APPLICATION FOR ZONING AMENDMENT
City of Portland, Maine
Department of Planning and Urban Development
Portland Planning Board

RE: Site Plan Review
Marriott Courtyard
2282 Congress Street

SUBJECT: Site Plan Review of 2282 Congress Street / Proposed Hotel

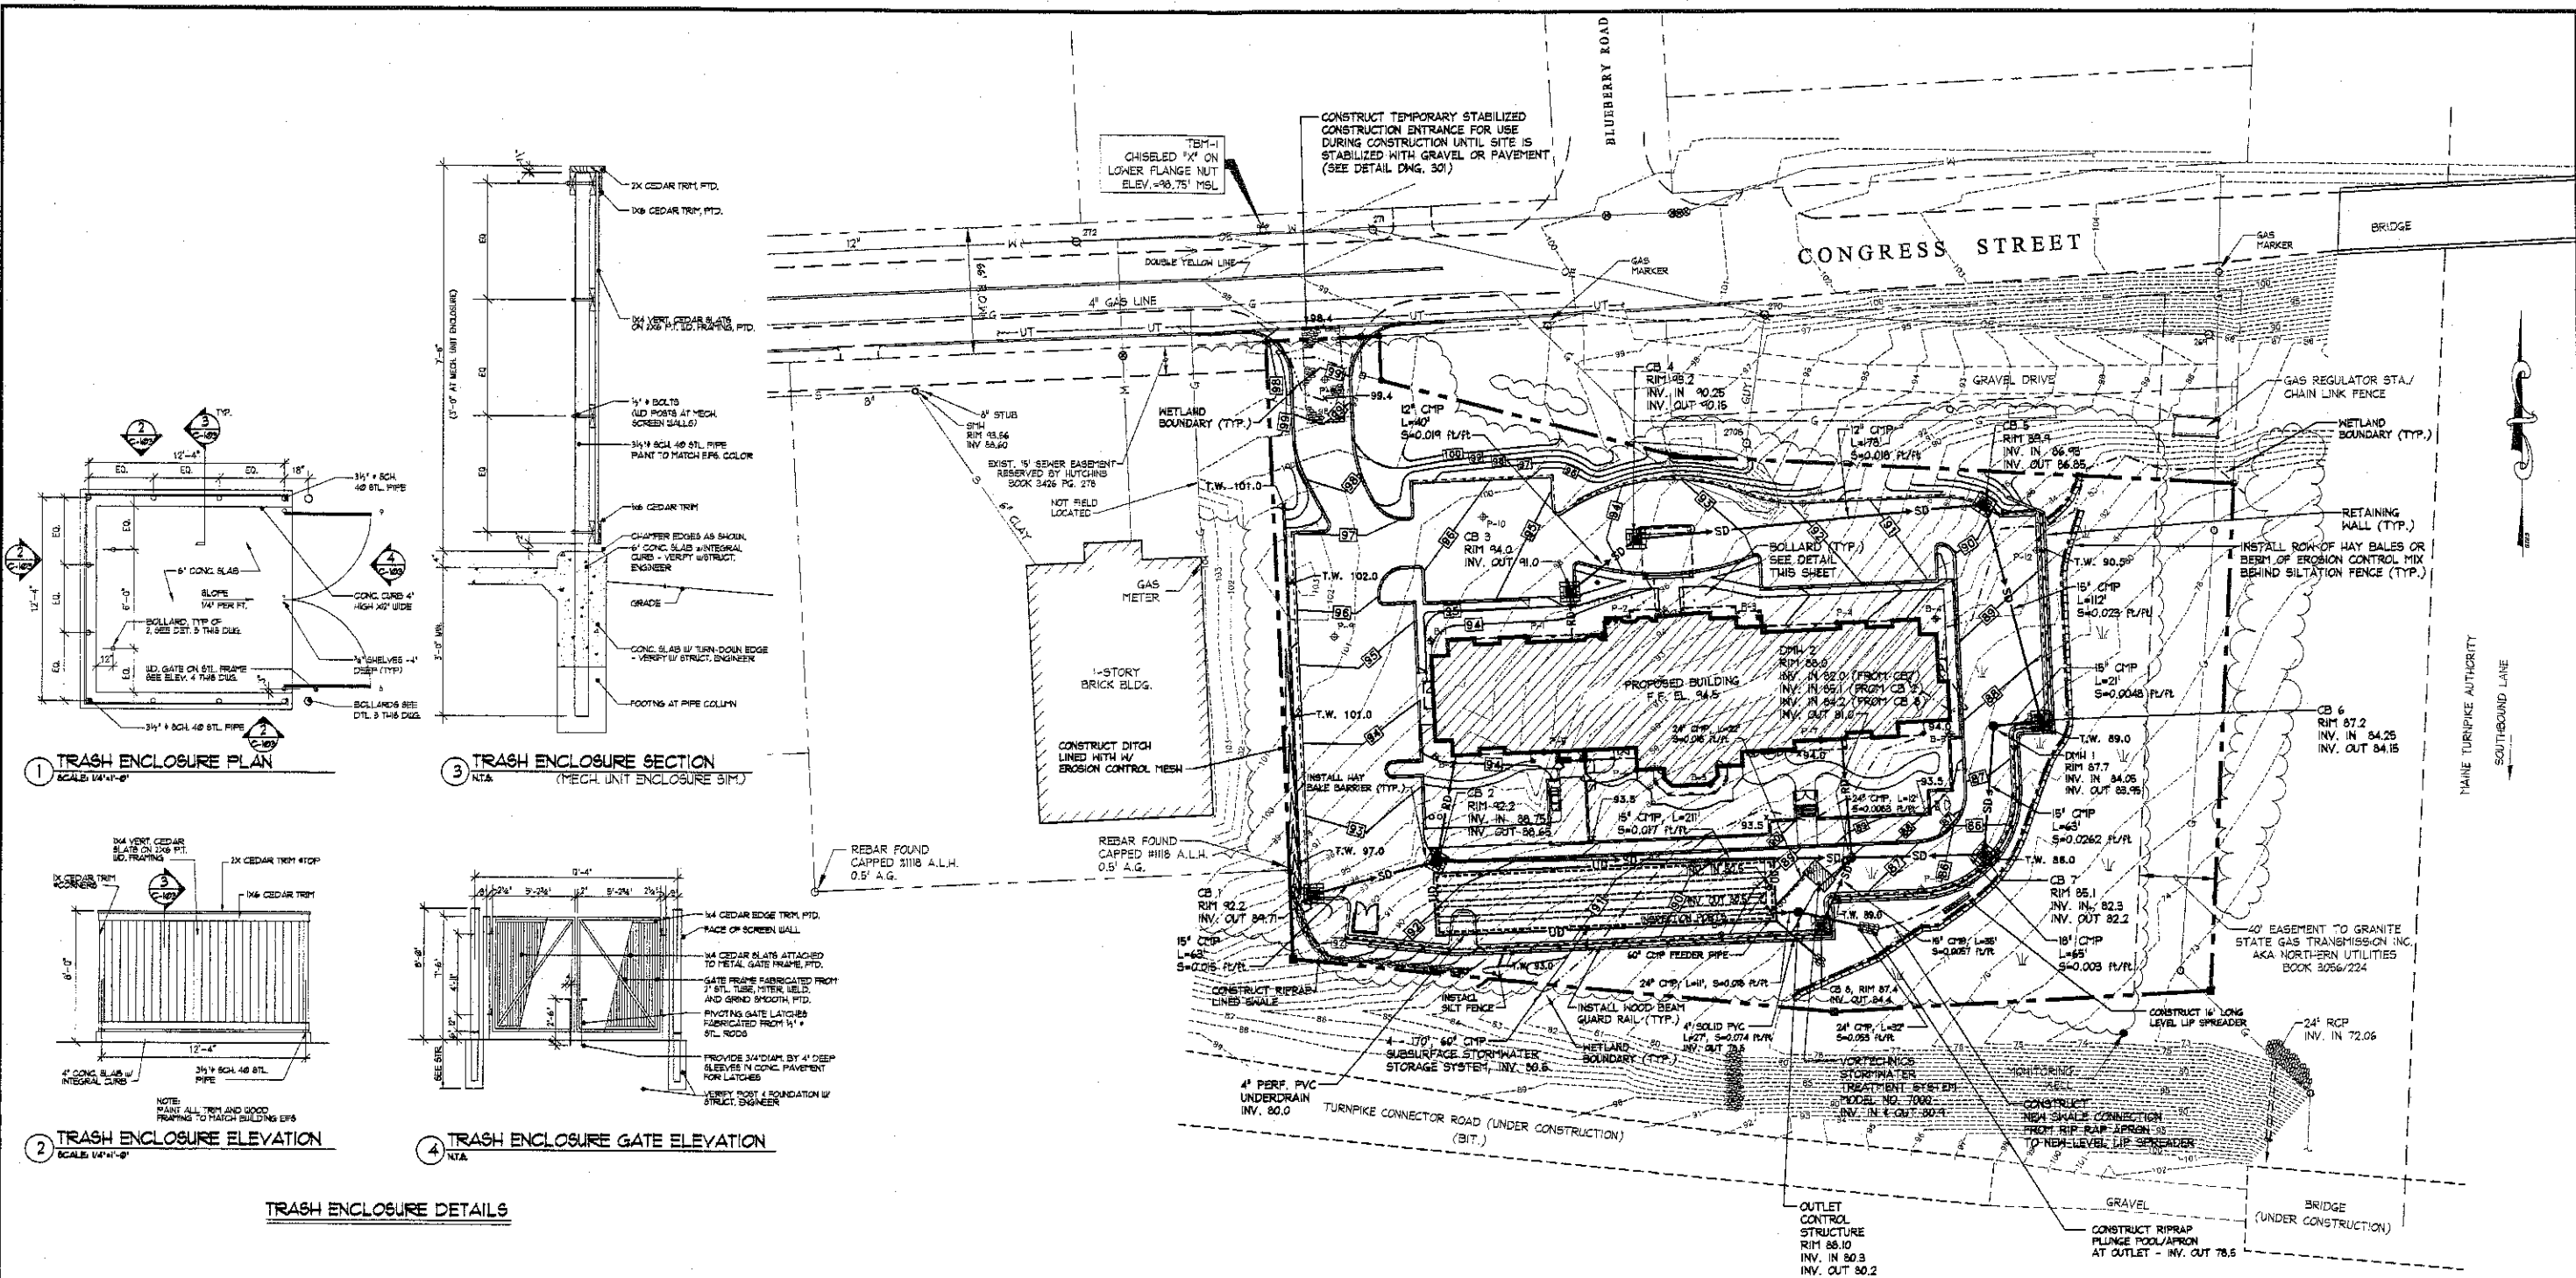
1. The Applicant has addressed items 1-16 outlined in Mr. Wendel's memorandum and the plans appear to meet the City Standards for stormwater management and erosion control.
2. The Applicant should review the proposed sanitary sewer service for minimum slope. The typical minimum slope for 8" pipe is 0.004 ft./ft. and for 10" pipe it is 0.0028 ft./ft. The Applicant should either try to steepen their slope from 0.0030 to 0.0040 or install 10" diameter pipe.
